IN THE DRAWINGS

Please amend the drawings as follows:

FIG. 1

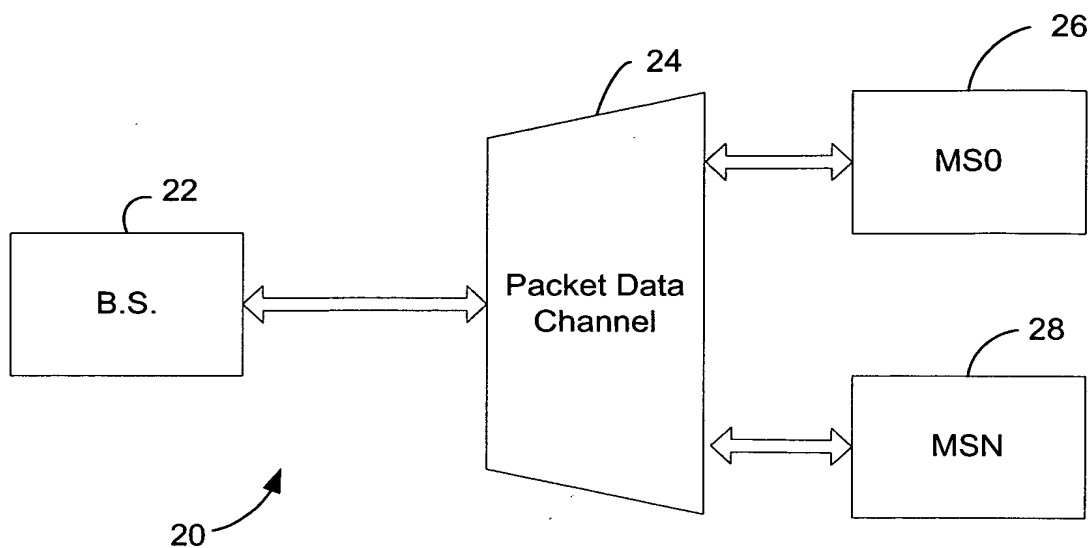
In FIG. 1, please add reference numeral "20" in FIG. 1.

FIG. 3

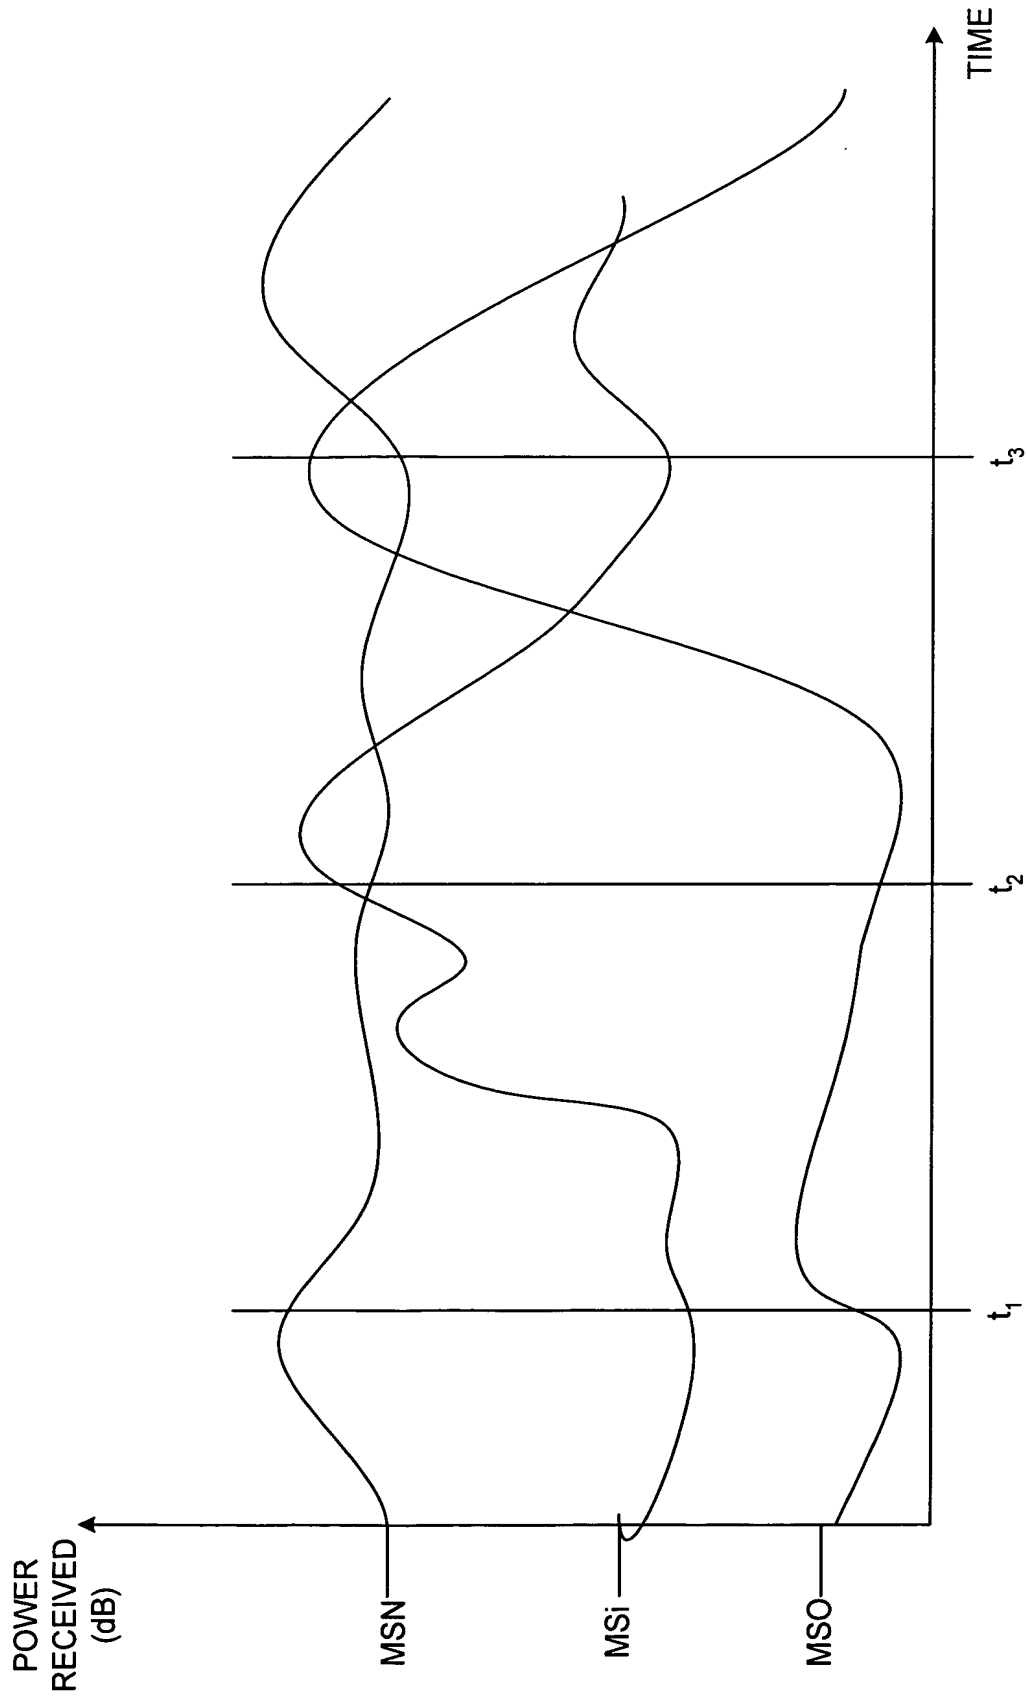
In FIG. 3, please change "db" to --dB--;

please increase the signal of MS_i at time t_2 above line MSN; and

please increase the signal of MSO at time t_3 above line MSN.

FIG. 7

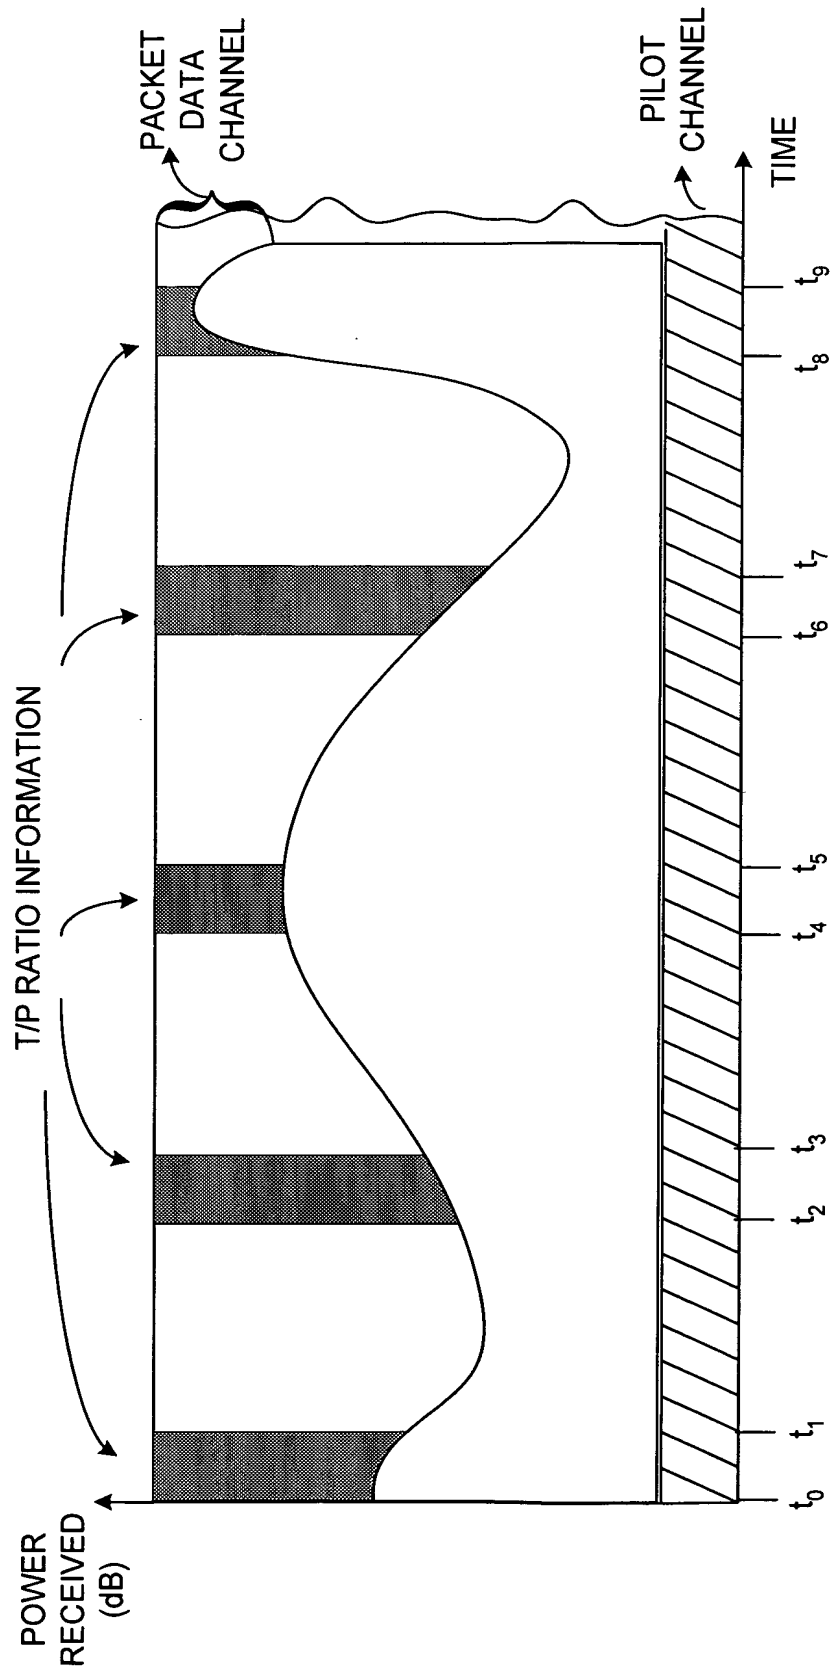
In FIG. 7, please change "PARALLEL SIGNAL CHANNEL" to --T/P RATIO INFORMATION--;

please delete the arrow from "T/P RATIO INFORMATION" to the traffic space between time t_1 and t_2 above;

please insert an arrow from "T/P RATIO INFORMATION" to the T/P ratio space between time t_0 and t_1 ; and

please mark the area corresponding to the PACKET DATA CHANNEL.

FIG. 8

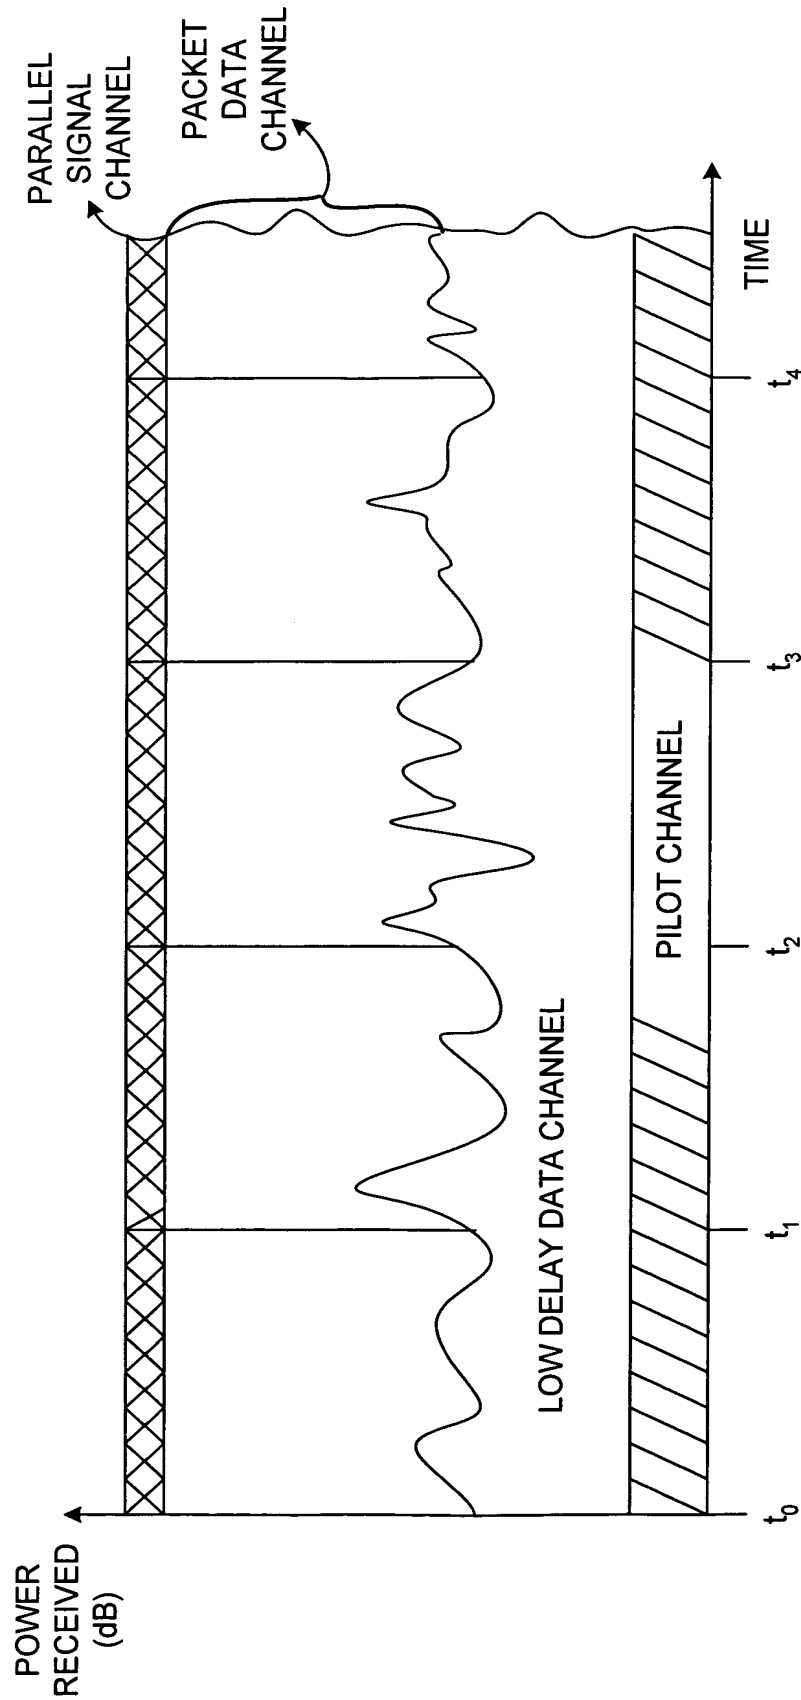
In FIG. 8, please mark the area corresponding to the PACKET DATA CHANNEL.

FIG. 9

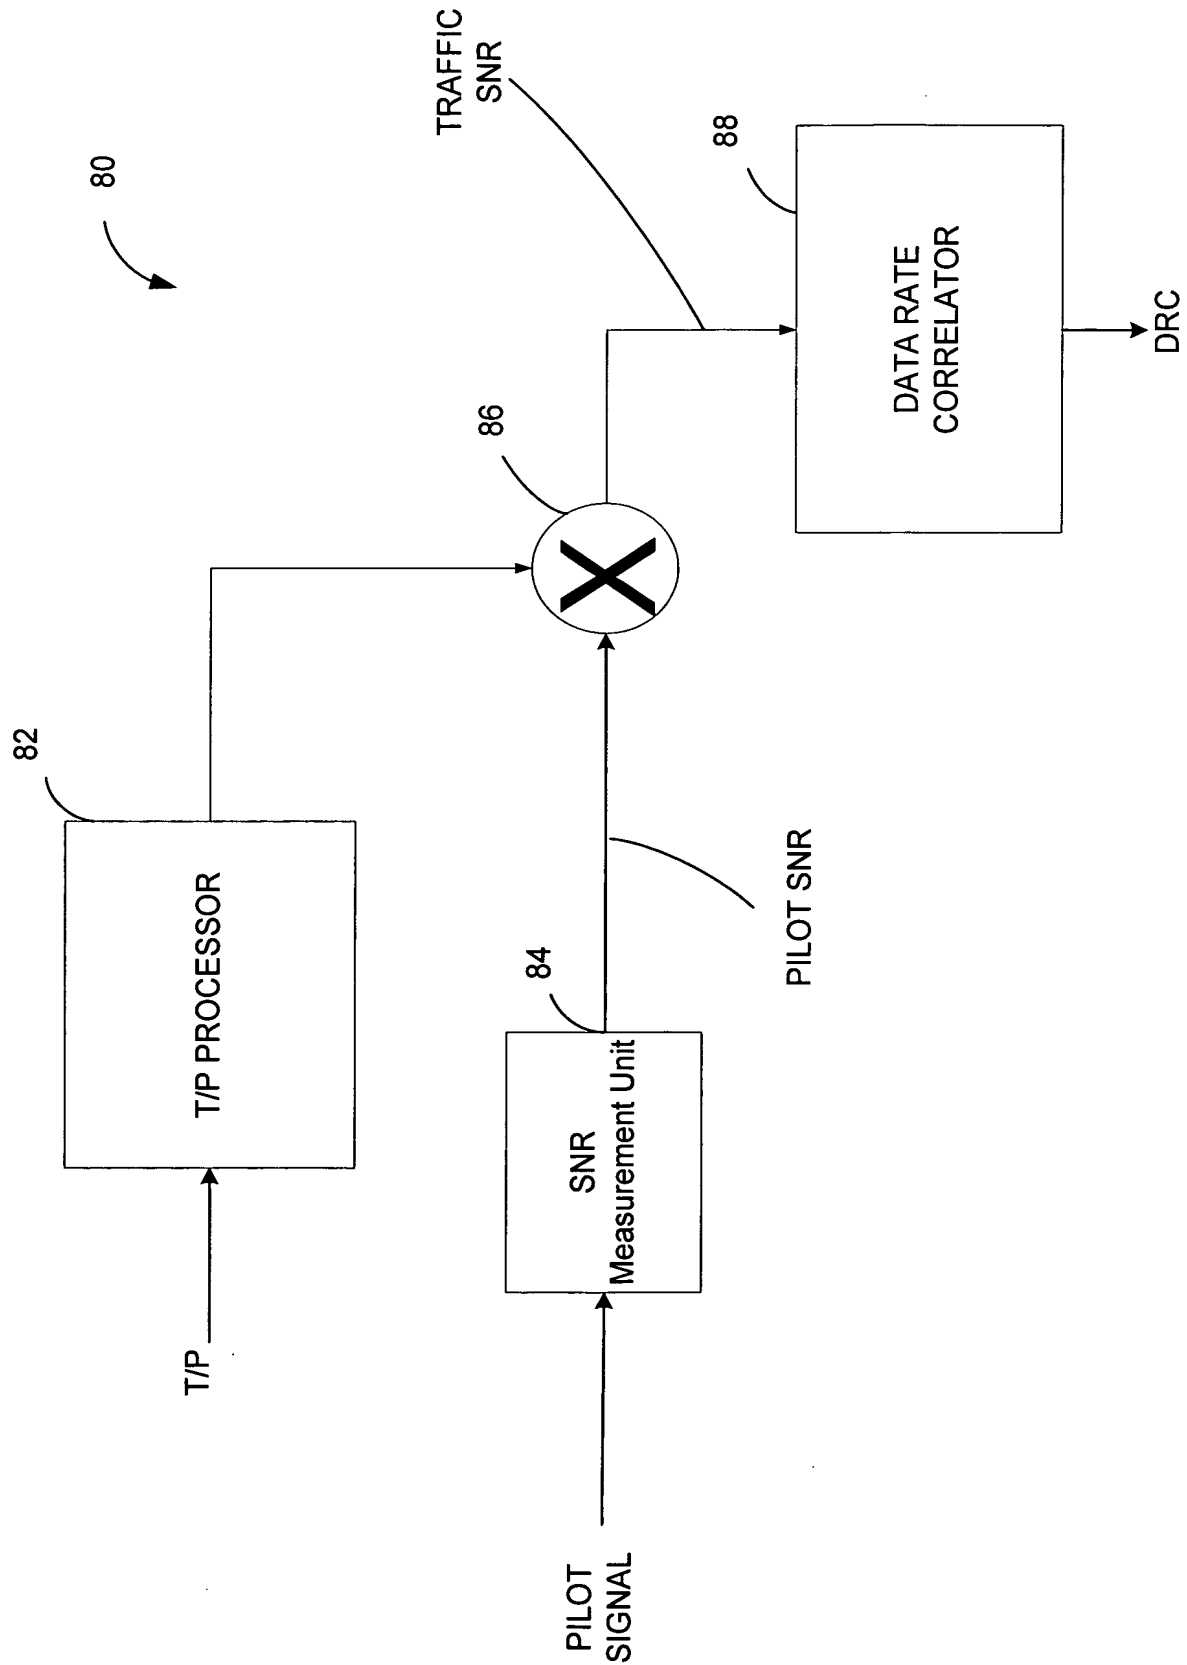
In FIG. 9, please change the text in box 88 to --DATA RATE CORRELATOR--.
